Dewsbury Bus Station Refurbishment - Stage 1 Road Safety Audit

B2382808/RSA1/01 | 1

West Yorkshire Combined Authority

Location: A – Bus stand 19

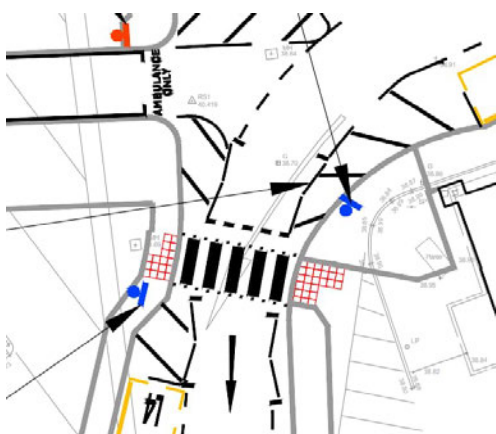
Summary: High kerb may lead to pedestrian injury

The kerbing proposed between the footway and the marked pedestrian route that guides passengers to board and alight vehicles using bus stand 19 is the same kerb type as that proposed at the bus stands further west (e.g. bus stand 18). The audit team assumes that bus stand 19 would be used by left-hand drive vehicles and that the kerbing type indicated in orange would be a high kerb suitable for level access of passengers boarding and alighting vehicles. If a high kerb type is provided at the point of access to the marked pedestrian route, then there is a risk of pedestrians suffering injury when negotiating the height difference. In addition, the high kerb would act as a barrier to wheelchair users and pedestrians with prams, increasing the risk of injury to these users should they attempt to negotiate the kerb, and potentially increasing their exposure to being struck by a vehicle accessing or egressing the bus stand.

Level access should be provided between the footway and the marked pedestrian route.

Location: B – Proposed crossing close to the ambulance waiting area

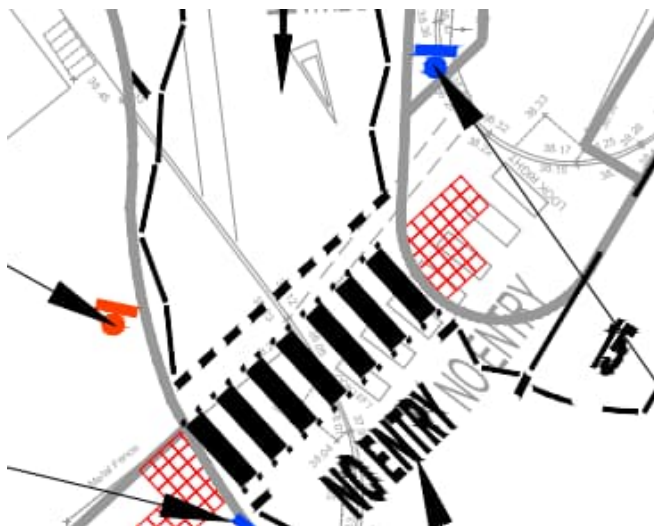
Summary: Insufficient space provided within the 'roadway' through the bus station

There are two locations where the audit team considers there may be an increased likelihood of collisions due to insufficient space being provided within the 'roadway' through the bus station. The first of these is at the proposed crossing close to the ambulance waiting area and the second is the 2-lane approach to the station exit. Insufficient space at the proposed crossing would increase the likelihood of vehicles striking pedestrians waiting to use the crossing. Insufficient space at the bus station exit would increase the risk of side swipe collisions.

The designer should satisfy themselves that the whole of the proposed internal network can accommodate the movements of the largest anticipated vehicle type, undertaking any swept path analysis as necessary.

Location: D – Zebra crossing at Aldams Road entry to bus station

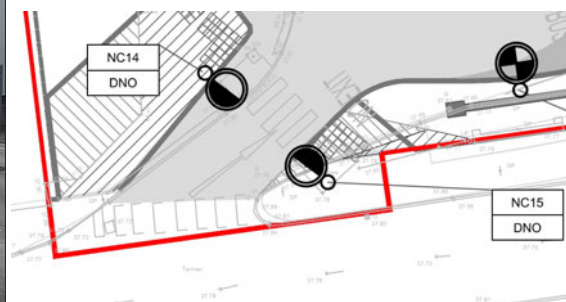
Summary: Reduced intervisibility between drivers and pedestrians using the crossing

Driver visibility of the proposed crossing will be reduced due to the number of signs at this entry to the bus station. However, it is not clear, from the proposals, which, if any, signs are being removed. The belisha beacon that is proposed on the south-eastern side of the crossing appears to be very close to an existing No Entry sign, which may reduce the visibility of both these elements to drivers. Reduced driver visibility to the crossing will reduce

driver awareness of the crossing and is likely to increase the risk of shunt (nose to tail) collisions, noting the potential for queued vehicles at the proposed crossing to block back onto Aldams Road.

Intervisibility is particularly poor between pedestrians waiting to cross from the north-western side of the crossing and drivers of eastbound vehicles approaching the crossing. A large bush obstructs visibility at this location. The bush appears to be within the ownership of the bus station.

The existing bush, west of the crossing, should be cut back and / or reduced in height to improve intervisibility between drivers and pedestrians using the crossing. Traffic signs at this entry to the bus station should be rationalised to maximise the conspicuity of the proposed crossing to drivers.

Location: E – Path provided along the southern boundary of the bus station

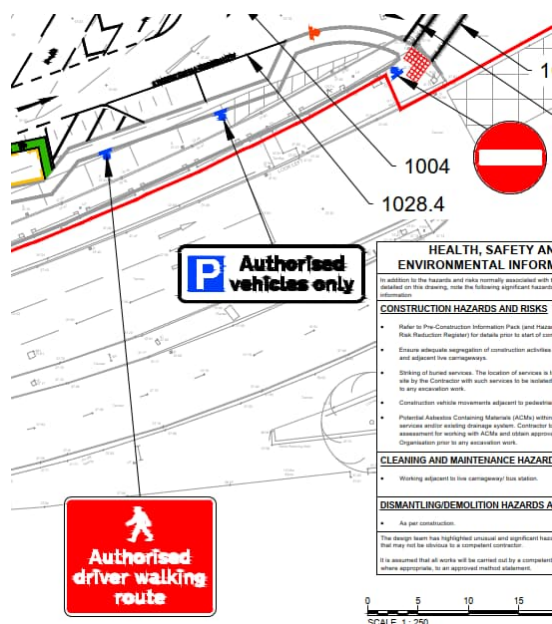
Summary: Potential for unauthorised pedestrians to walk along the path

A sign is proposed on the path provided along the southern boundary of the bus station to indicate that the path is a walking route for authorised drivers. The sign is proposed to be located approximately 40m west of the signalised crossing at the bus station exit junction. It is not clear whether the existing signing provided close to the crossing, and which indicates no access for pedestrians, is being retained. The proposals may lead to an increased likelihood of unauthorised pedestrians walking along the path provided adjacent to the southern boundary of the bus station. There is therefore an increased risk of pedestrians walking in areas where buses are manoeuvring and associated collisions involving pedestrians being struck by buses.

Signing to advise pedestrians that the path is for authorised users only should be provided close to the signalised crossing at the bus station exit.

Location: F – Bus station exit onto Aldams Road

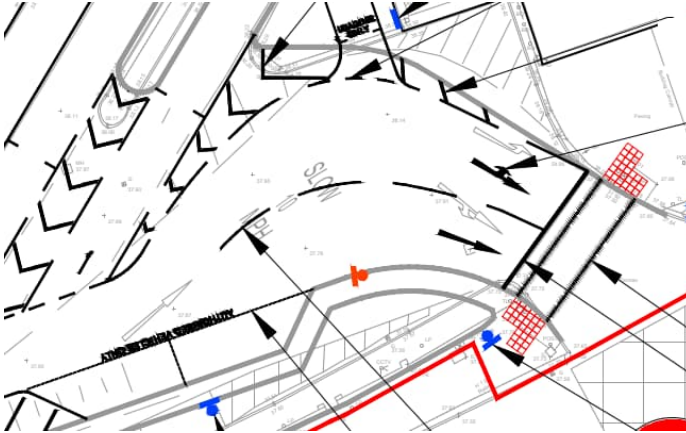
Summary: Ahead arrow marking in two lanes but junction exit has only a single lane

An ahead arrow marking is shown in both lanes at the exit from the bus station, however the downstream exit from the signalised junction (B6409) has only a single lane. There is therefore an increased likelihood of side swipe collisions if two vehicles attempt to travel ahead side by side when exiting the bus station.

In addition, the offside lane of the exit from the bus station is marked for the ahead movement only. Drivers seeking to turn right onto Aldams Road may be confused when faced with an ahead arrow, with an increased likelihood of collisions resulting from driver hesitancy or late manoeuvres.

The ahead arrow marking should be omitted from the nearside lane of the bus station approach to the junction. The alignment of the bus station approach lanes and B6409 exit are such that the ahead movement is best accommodated in the offside lane of the bus station approach. The offside lane should be marked for ahead and right turning vehicles.
